## Hornsea Project Three Offshore Wind Farm

Statement of Common Ground between Hornsea Project Three  
(UK) Ltd. and Highways England

Project:	<b>Highways England Spatial Planning Arrangement 2016-2020</b>	Job No:	<b>60506522 / DN055.002</b>
Subject:	<b>Hornsea Project Three Offshore Wind Farm – Impact on the A47/ Taverham Road junction at Honingham</b>		
Prepared by:	<b>Andrew Cuthbert</b>	Date:	<b>16<sup>th</sup> November 2018</b>
Checked by:	<b>Andrew Beard</b>	Date:	<b>19<sup>th</sup> November 2018</b>
Verified by:	<b>John Alderman</b>	Date:	<b>19<sup>th</sup> November 2018</b>
Approved by:	<b>Andrew Cuthbert</b>	Date:	<b>19<sup>th</sup> November 2018</b>

Project:	<b>Highways England Spatial Planning Arrangement 2016-2020</b>	Job No:	<b>60572359/ DN055.002</b>
Subject:	<b>Hornsea Project Three Wind Farm PIA Review</b>		
Prepared by:	<b>Kathryn Carman</b>	Date:	<b>19<sup>th</sup> November 2017</b>
Checked by:	<b>Kimberley Pettingill</b>	Date:	<b>19<sup>th</sup> November 2017</b>
Verified by:	<b>Andrew Cuthbert</b>	Date:	<b>19<sup>th</sup> November 2017</b>
Approved by:	<b>Andrew Cuthbert</b>	Date:	<b>19<sup>th</sup> November 2017</b>

**Figure 2.1 – Crashmap A47/Taverham Road Junction Assessment**

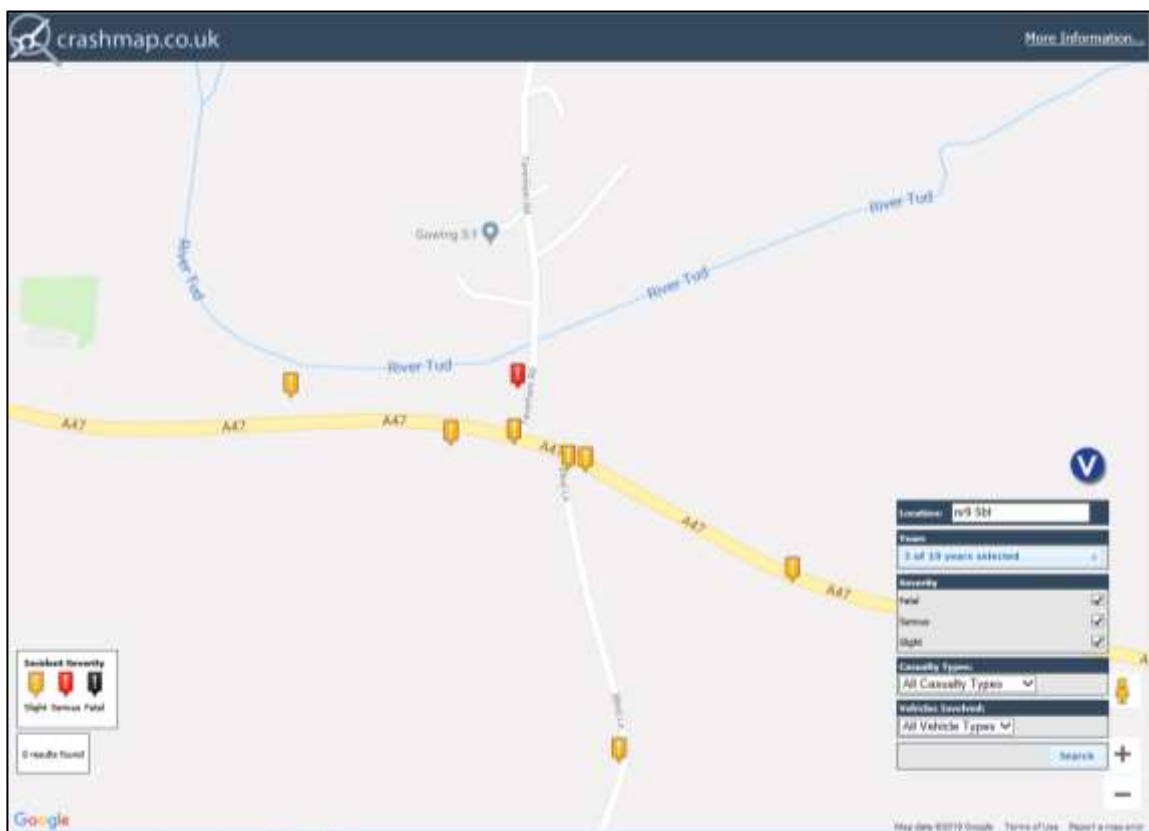
5. **Paragraphs 2.20 – 2.24** and **Figure 2.1** of the RN suggest that a total of eight PIAs were recorded across the study area from the information provided by crashmap.co.uk, with seven resulting in slight injuries and one in serious injuries. No PIAs recorded within the last three years (up to the end of 2017) resulted in a fatality. AECOM have undertaken an independent review using Crashmap and note that a total of ten collisions were recorded across the study area during the study period. Therefore, two collisions, recorded as slight in severity, have been omitted, bringing

the total collisions in the study area to ten over the three year period. One of these collisions occurred approximately 35m west of the A47/ Taverham Rd junction and the other at the junction of A47/ Blind Lane. Given the RN is dated November 2018, there doesn't appear to be a logical explanation as to why these two collisions have been omitted.

- 4.26 The Crashmap data depicted in Figure 2.1 shows that only one accident occurred on the A47 immediately adjacent to the Taverham Road junction. This accident is classified as ‘Slight’ in severity and was recorded on the 15 January 2016 involving two vehicles resulting in one casualty.
- 4.27 Figure 2.1 also shows an accident recorded on Taverham Road approximately 35m north of the junction with the A47. This accident occurred on 26 July 2017 and is classified as ‘Serious’ in severity involving two vehicles and one casualty.

- 4.28 The next closest accident to the A47/Taverham Road junction was recorded on 4 May 2018, approximately 50m to the west on the A47. This incident was classified as 'Slight' in severity involving two vehicles and two casualties.

- 4.29 The two accidents shown to the east of Taverham Road along the A47 are more closely linked to the Blind Lane junction to the south and therefore are not relevant to this assessment.
